Application for Variation of an Environmental Permit

Central-Wan Chai Bypass –Tunnel (North Point Section) and Island Eastern Corridor Link

Environmental Review Report for Alternative Arrangement for Installation of Noise Barriers and Semi-enclosures on the Island Eastern Corridor

Figure a - Elevation for 3.5m High Noise Barrier Between Piers 17 and 22 as Temporary Noise Mitigation

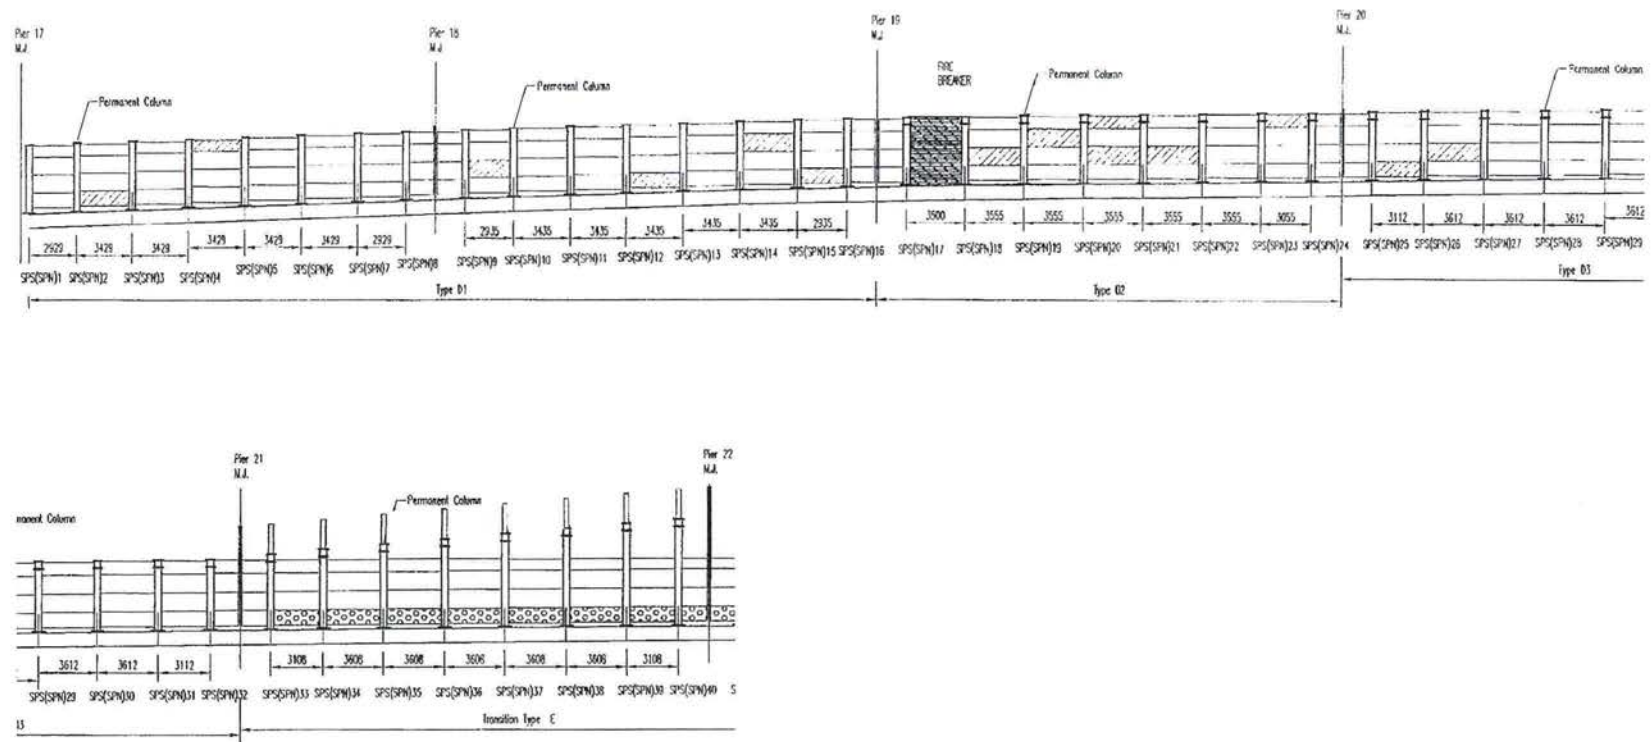
- 3.3 To mitigate the construction noise impact for the installation of the remaining permanent noise semi-enclosures due to the incomplete noise semi-enclosure between IEC westbound Pier 17 and Pier 22, a 3.5m high vertical noise barrier with PMMA panels with same specification as the noise barriers in item (a) of Condition 2.10 of the EP and FEP will be installed along the edge of IEC Pier 17 to Pier 22 as temporary noise mitigation measures (refer to **Figures a and b in Appendix 1**) prior to the commencement work of above construction work.

- 4. Conclusion**
- 4.1 With the temporary 3.5m high vertical noise barrier with PMMA panels placed as indicated in **Figures a** and **b** in **Appendix 1**, the construction noise arises from the installation of noise semi-enclosure between IEC westbound Pier 17 and Pier 22 complies with the construction noise criteria (75dB(A)).

Figure 4a: Locations of Direct Noise Mitigation Measures
 圖 4a: 直接噪音緩解措施位置圖

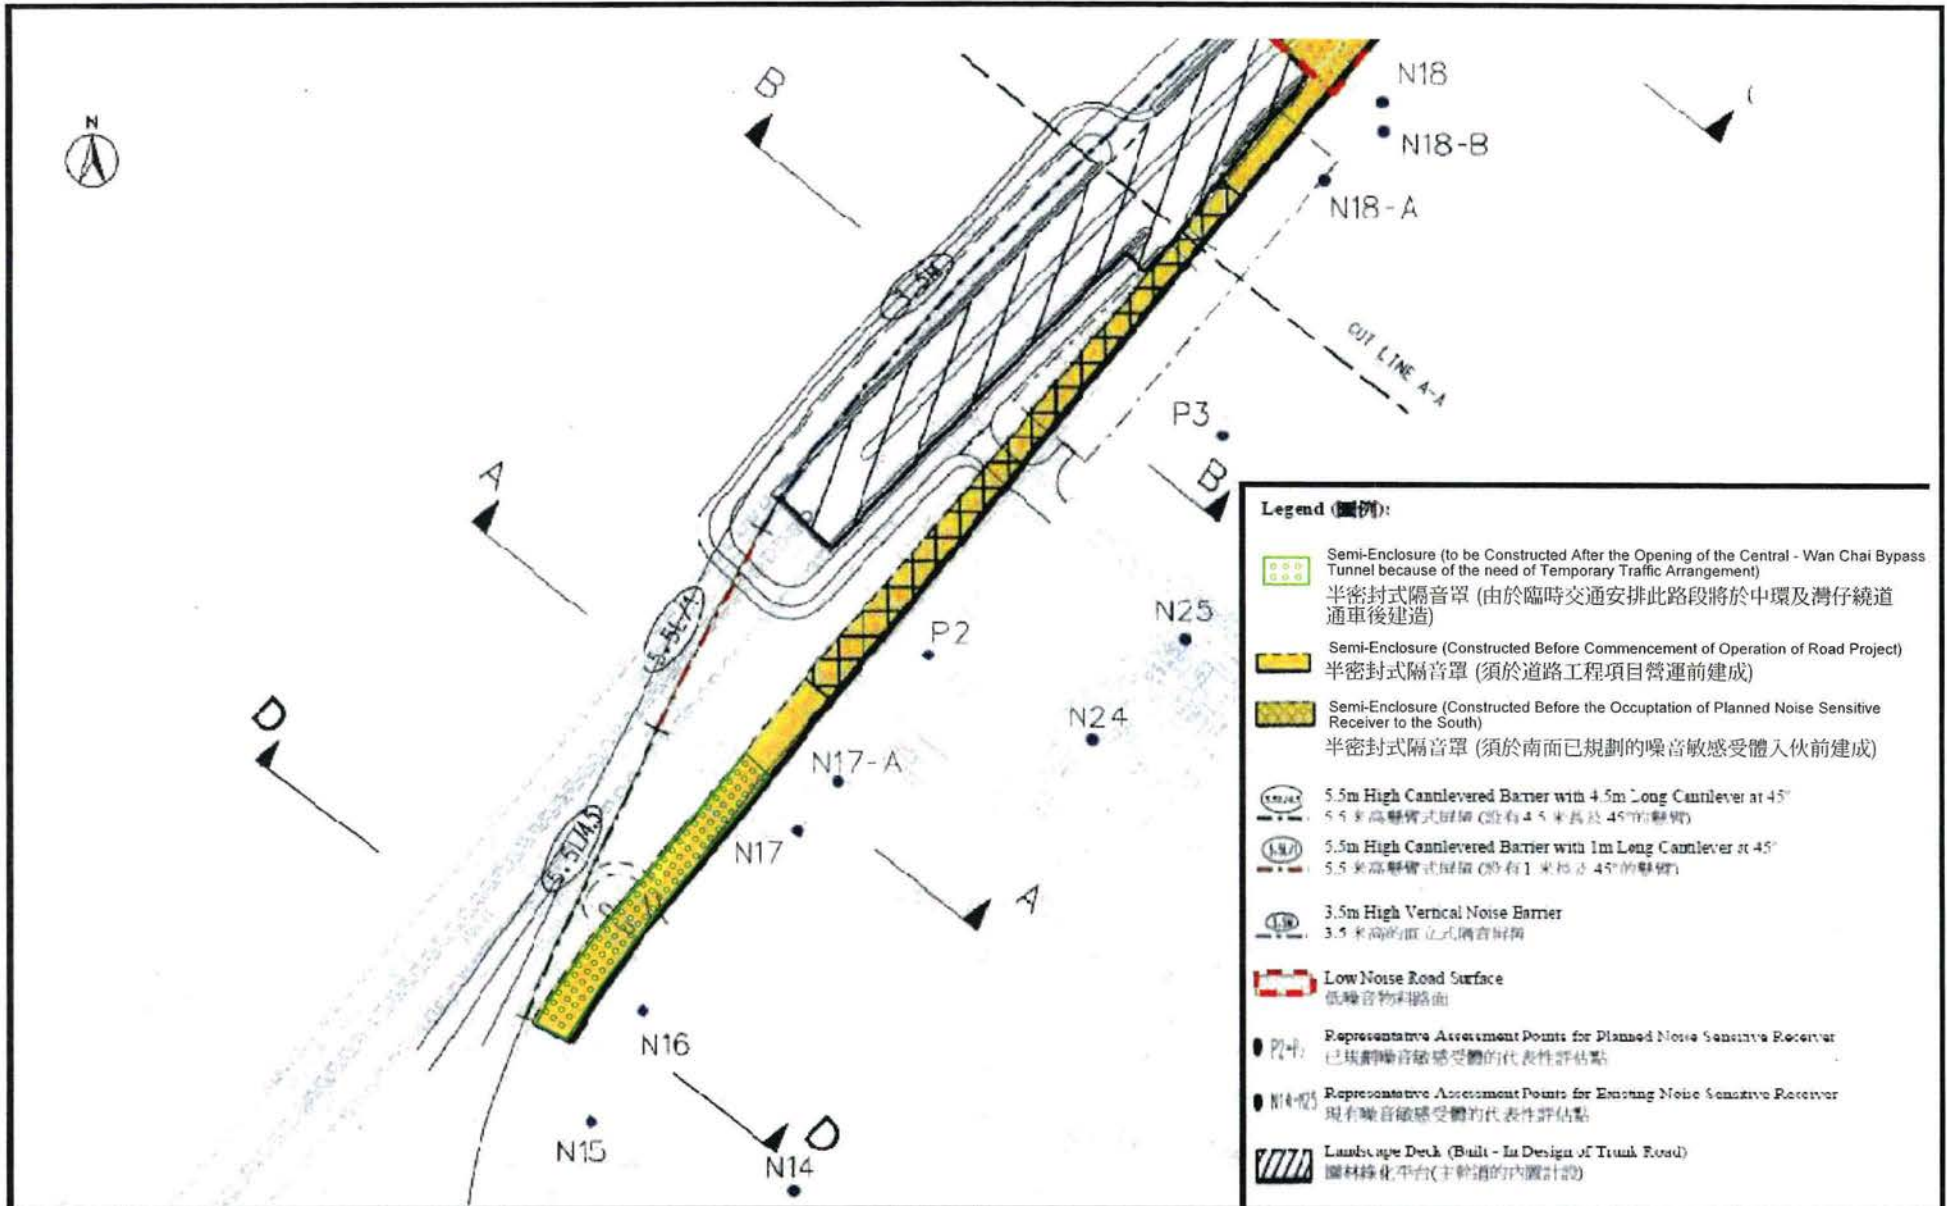
- 2.6 Temporary Traffic Arrangement (TTA) at the concerned road sections between Piers 17 and 22 will be implemented after the CWB tunnel is opened due to traffic constraint (refer to **Figure 4a in Appendix 1**)
